SAN FRANCISCO PLANNING DEPARTMENT

Certificate of Appropriateness Executive Summary

Record No.: 2019-021832COA
Project Address: 300 BARTLETT STREET (aka. 3359 24TH STREET)
Landmark No.: 234 (Mission Branch Carnegie Library)
Zoning: P (PUBLIC) Zoning District
55-X Height and Bulk District
Block/Lot: 6515/001
Project Sponsor: Andrew Sohn, San Francisco Public Works
49 South Van Ness Avenue
San Francisco, CA 94103
Staff Contact: Stephanie Cisneros - 415-575-9186
Stephanie.Cisneros@sfgov.org
Recommendation: **Approve with Conditions**

STAIR PLANS AND SECTIONS

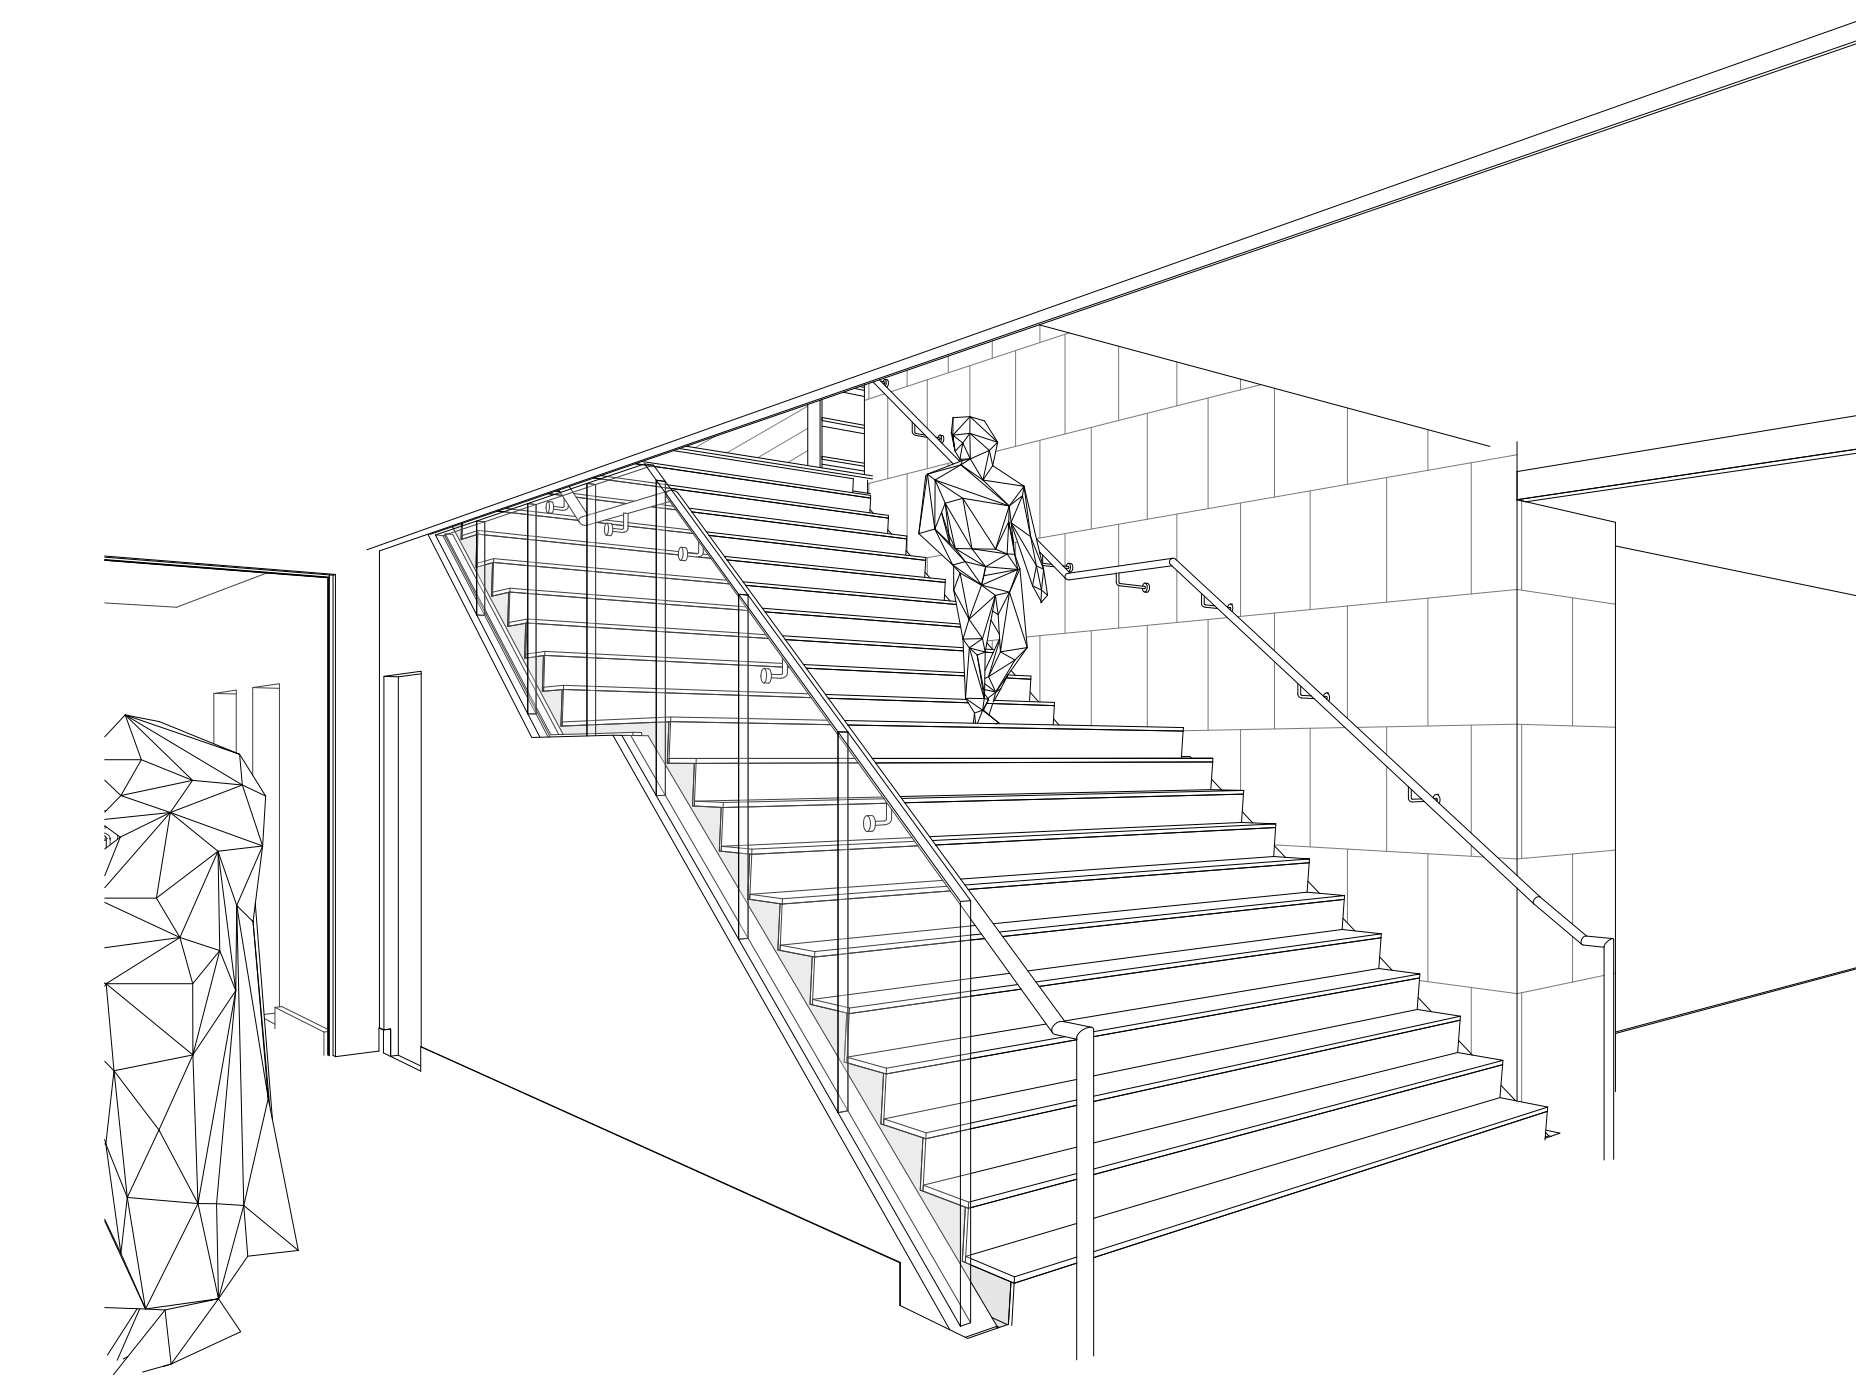
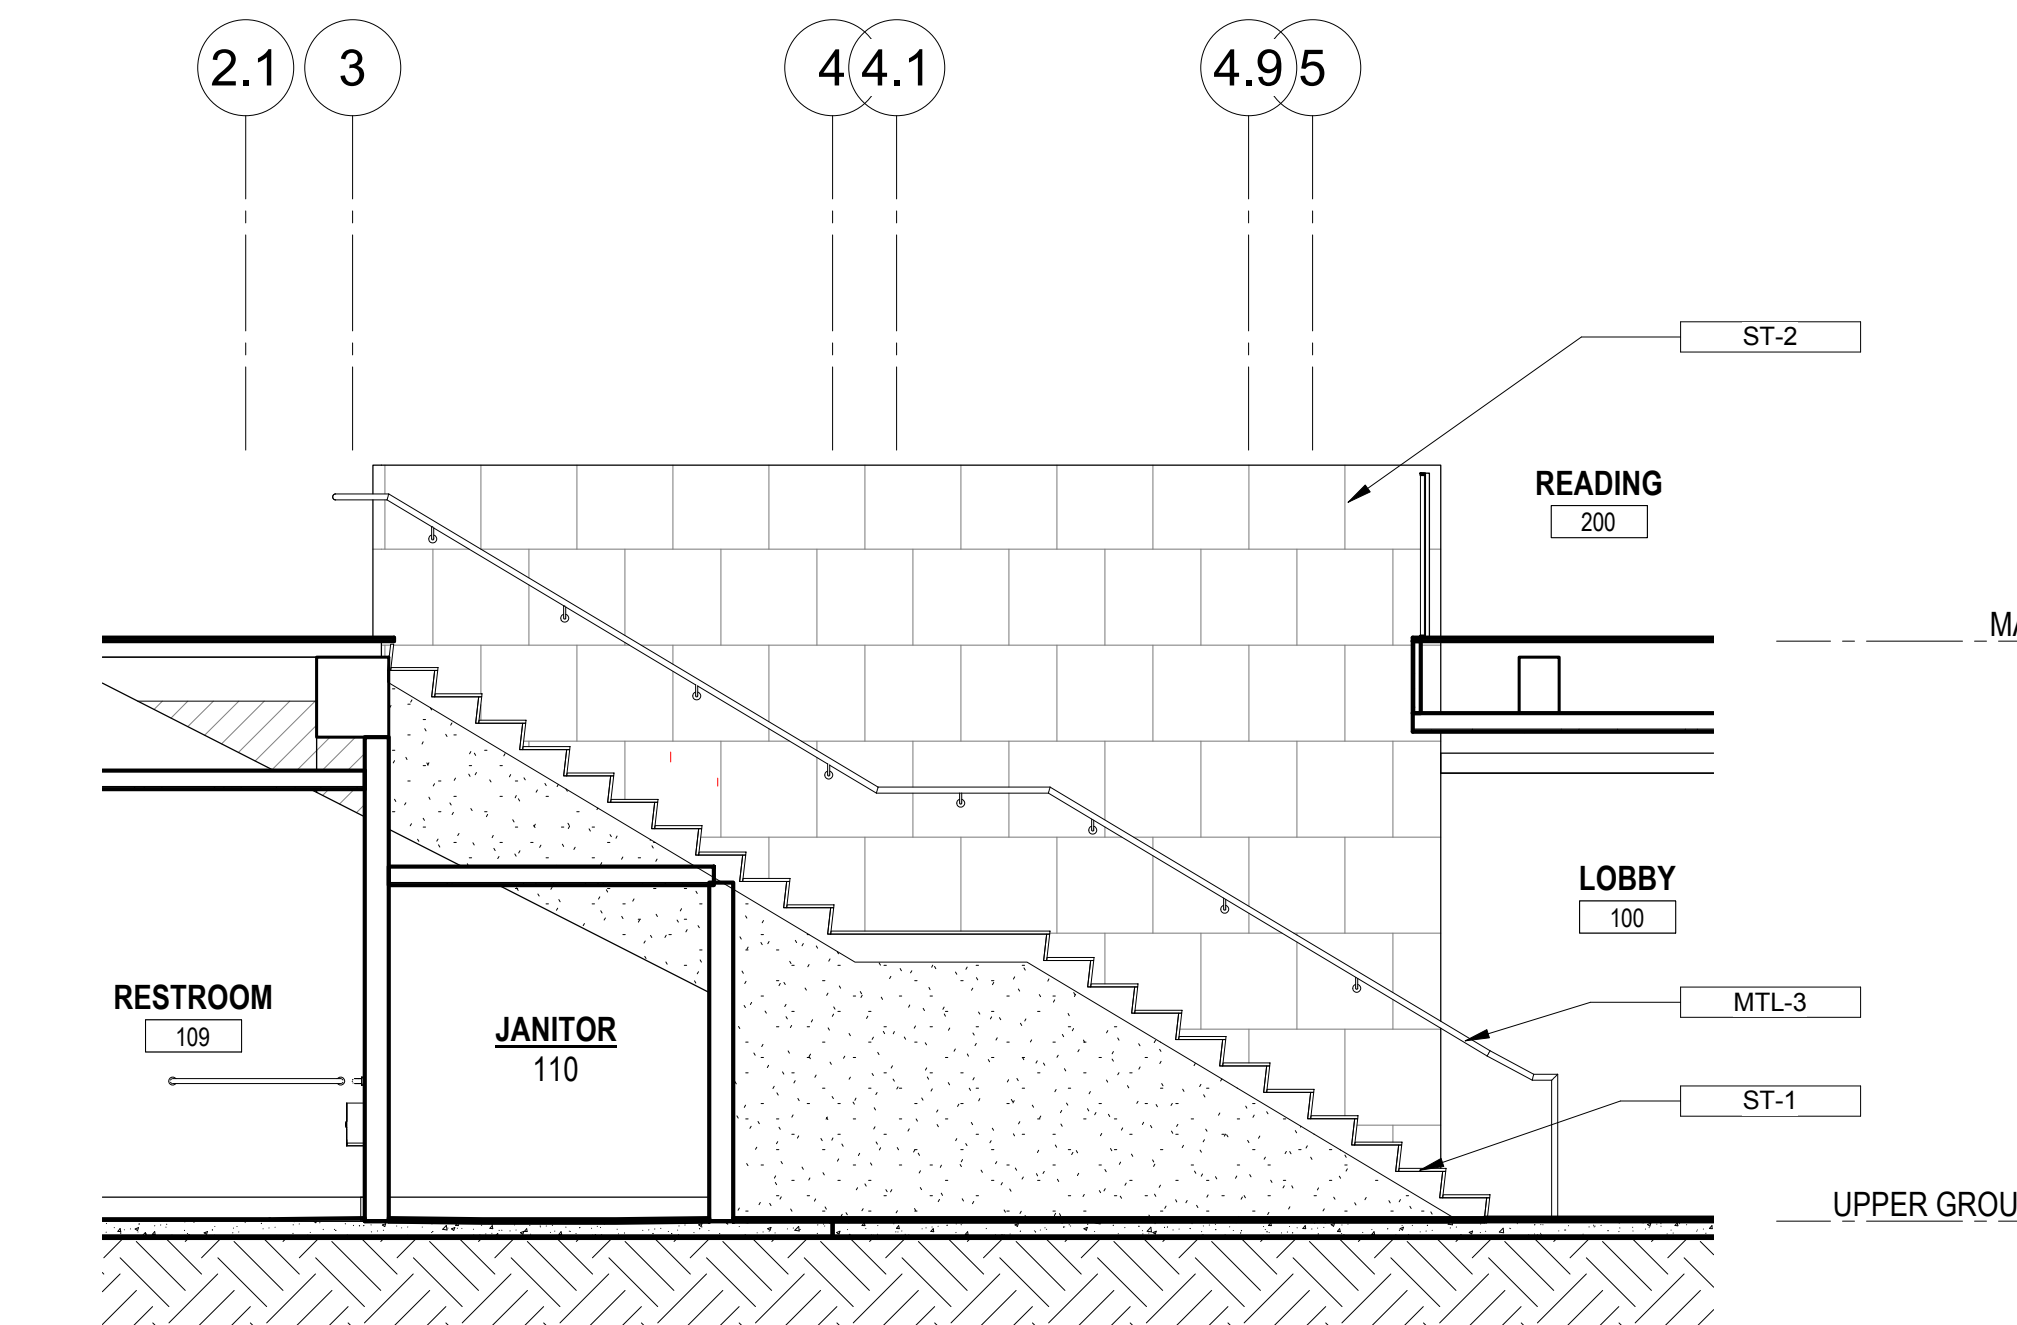
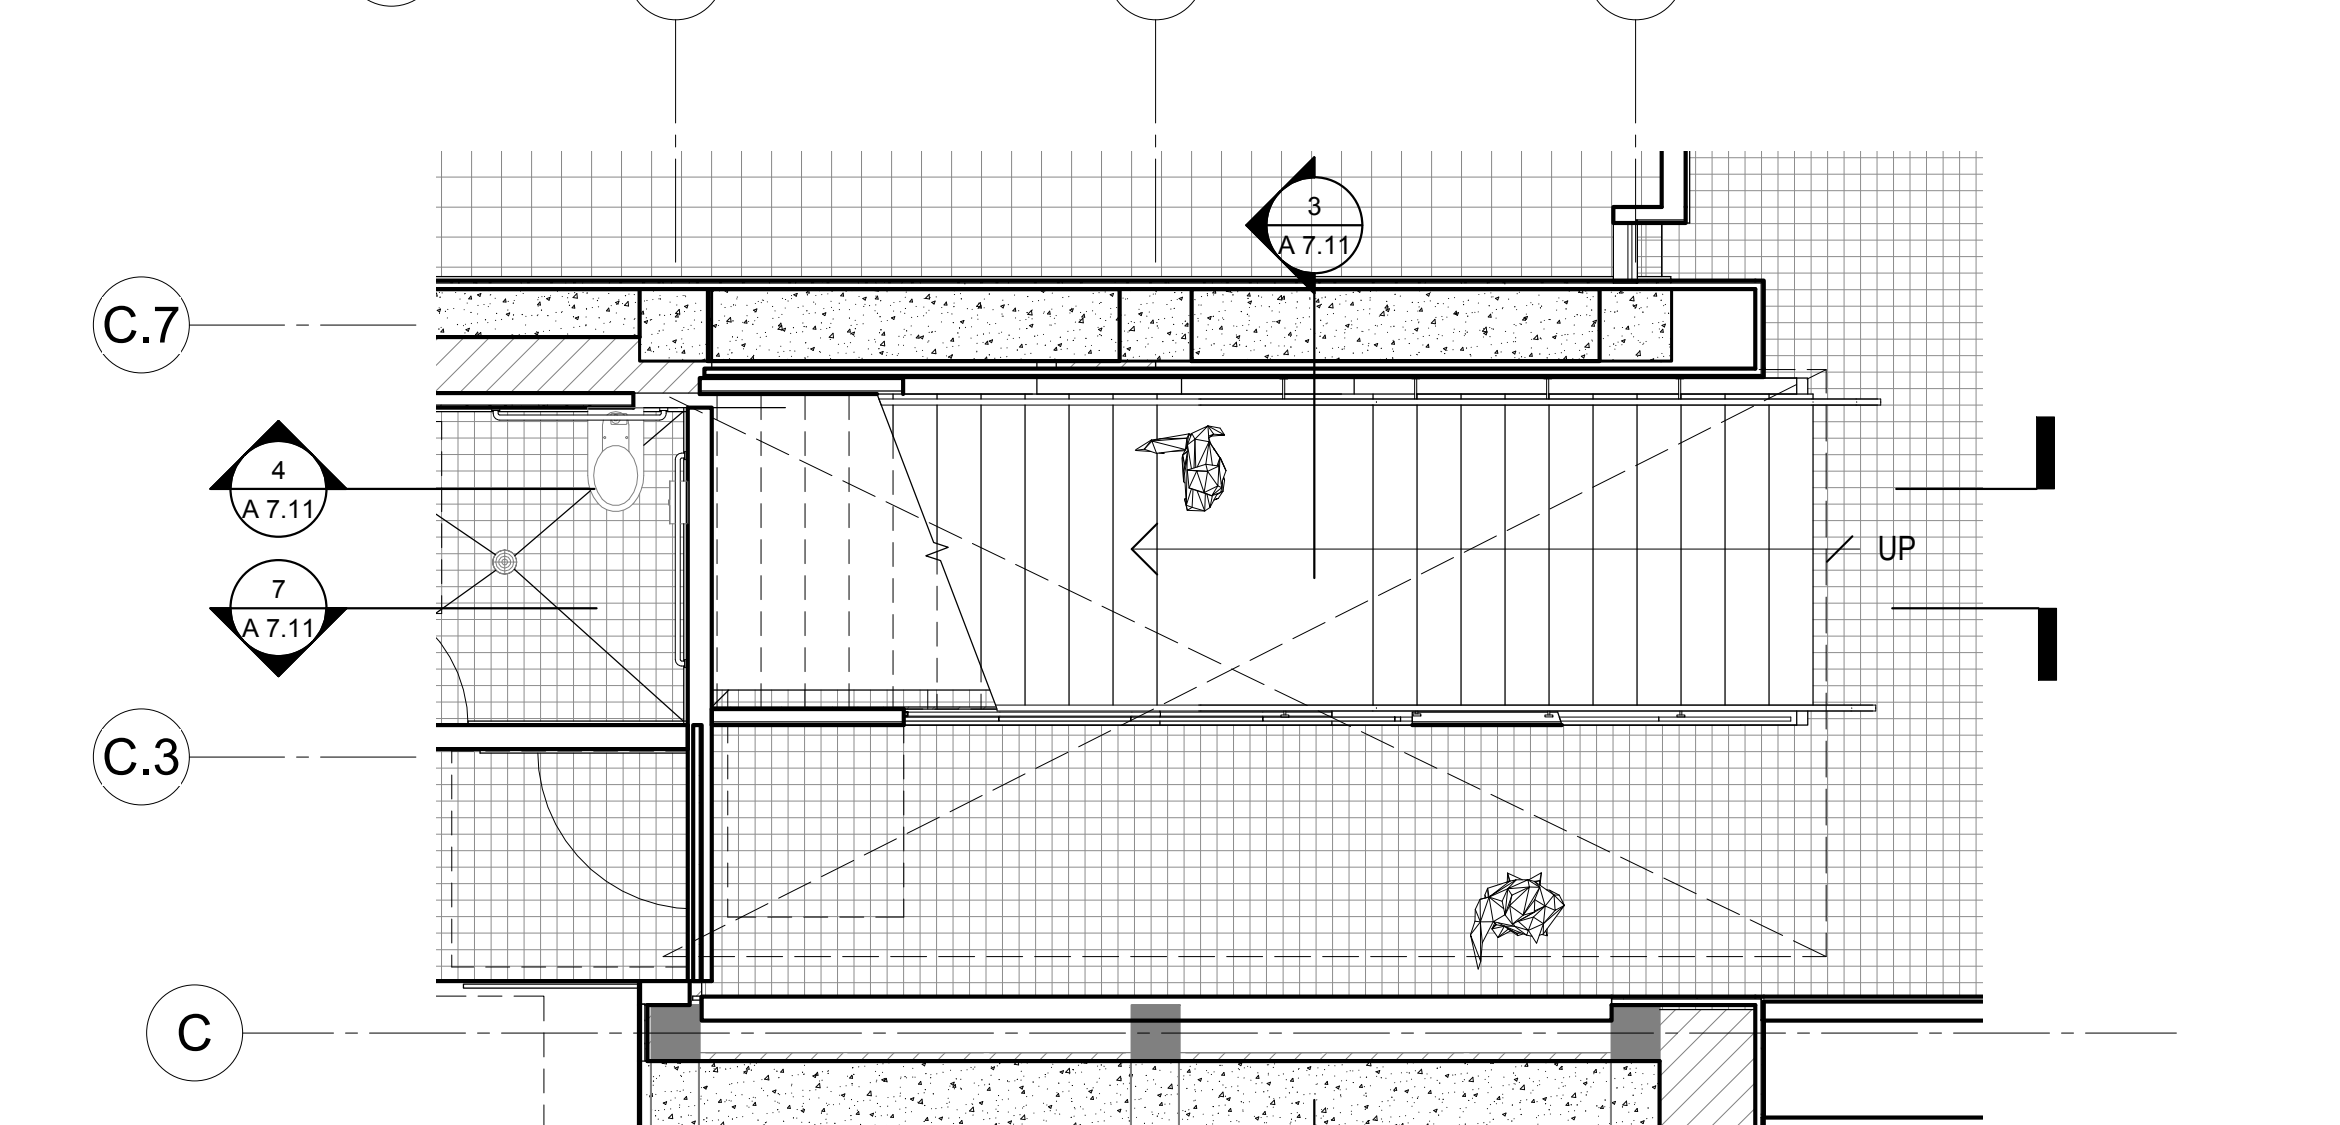
- **Central Stair:** At the April 15, 2020 ARC hearing, the Commissioners commented that the materials of the guardrail at the top of the new central stair should be revised from glass to a material(s) and design that would better correlate with that of the historic stair based on historic documentation. Staff is concerned that the Project Sponsor did not adequately address ARC's comment(s) regarding the materials and design of the central stair railing and recommends that it be further revised to do so.

- Prior to the issuance of a site permit, the Project Sponsor shall revise the fence along Bartlett Street per comment(s) provided by the ARC.
- Prior to the issuance of a site permit, the Project Sponsor shall work with staff on designing a new central stair that is reflective of the historic stair in both materials and design, based on available historic documentation.
- Prior to the issuance of a site permit, the Project Sponsor shall provide a salvage and/or storage plan for exterior materials to be removed to accommodate the new addition.
